MINERALS PROGRAM INSPECTION REPORT

MINE NAME: Cresson Project	MINE/PROSPECTING ID#: M-1980-244	MINERAL: Gold	COUNTY: Teller
INSPECTION TYPE: Monitoring	INSPECTOR(S): Elliott Russell	INSP. DATE: August 10, 2021	INSP. TIME: 10:00
OPERATOR: Cripple Creek & Victor Gold Mining Company	OPERATOR REPRESENTATIVE: Justin Raglin	TYPE OF OPERATION: 112d-3 - Designated Mining Operation	
REASON FOR INSPECTION: Priority	BOND CALCULATION TYPE: None	BOND AMOUNT: \$209,491,188.00	
DATE OF COMPLAINT: NA	POST INSP. CONTACTS: None	JOINT INSP. AGENCY: None	
WEATHER: Clear	INSPECTOR'S SIGNATURE: 	SIGNATURE DATE: September 30, 2021

Photo 14. Additional washout of DCF within VLF 2; looking north.

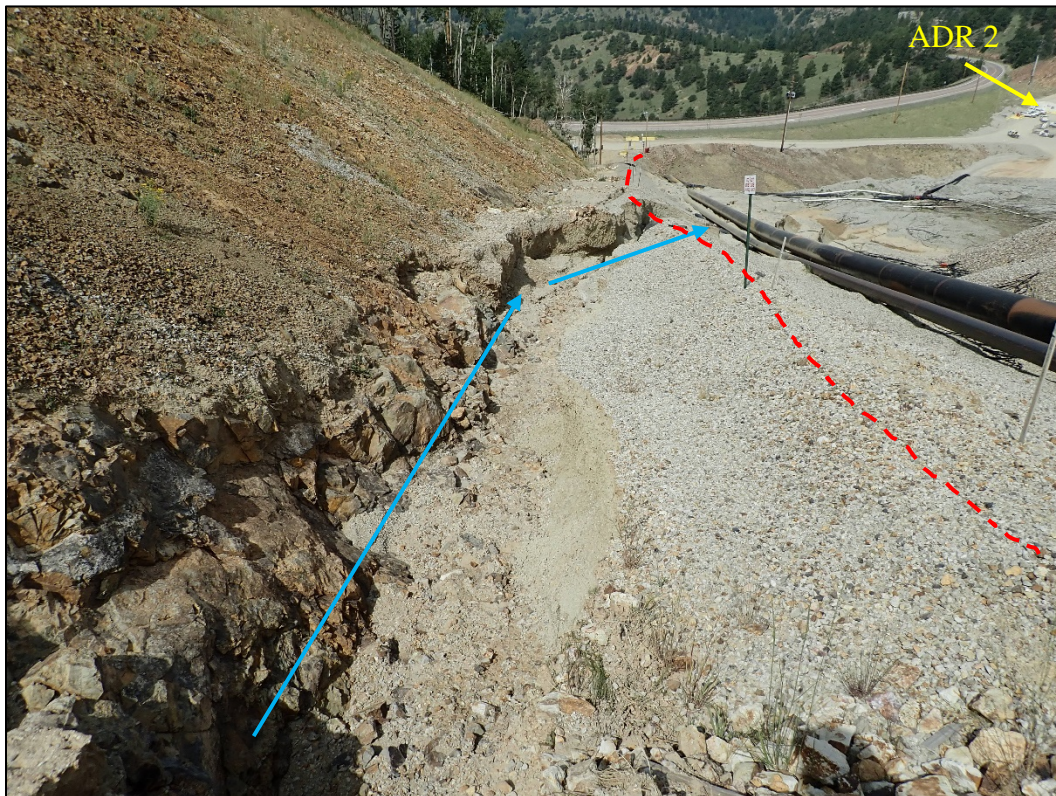
COMPLIANCE PROBLEM #1: A storm event caused Drain Cover Fill to washout in several areas of the Valley Leach Facility 2. The Drain Cover Fill was previously certified as a part of the Environmental Protection Facility and therefore these areas need to be repaired and recertified in accordance with Rule 7.3 and 7.4.

The Division also observed the area where stormwater caused DCF to washout and expose the liner on the north end of VLF 2 (see **Photo 14**). This washout was approximately 100 feet in length and appears to originate from a cross-contour light utility truck access road constructed on the DCF. The Operator indicated this washout was between 10,150' and 10,050'.

As discussed with the Operator during the inspection and further discussed in an email from the Division on August 19, 2021, the Operator will need to have the areas which were damaged by stormwater on VLF 2 recertified. This has been cited as Compliance Problem #1. Recertification, in accordance with Rule 7.3 and 7.4, will need to be completed by appropriate quality assurance and control on the repair work to meet the approved specifications and the submittal of a final recertification report is required. In accordance with the approved specifications, DCF will need to be replaced in the areas where the stormwater caused the originally-certified material to washout. Additionally, an evaluation of the exposed liner and anchor trench, recertifying their integrity, will need to be included within the final recertification report.

CORRECTIVE ACTIONS: The Operator shall repair and recertify the areas damaged by the storm event within the Valley Leach Facility 2 Environmental Protection Facility by the corrective action date.
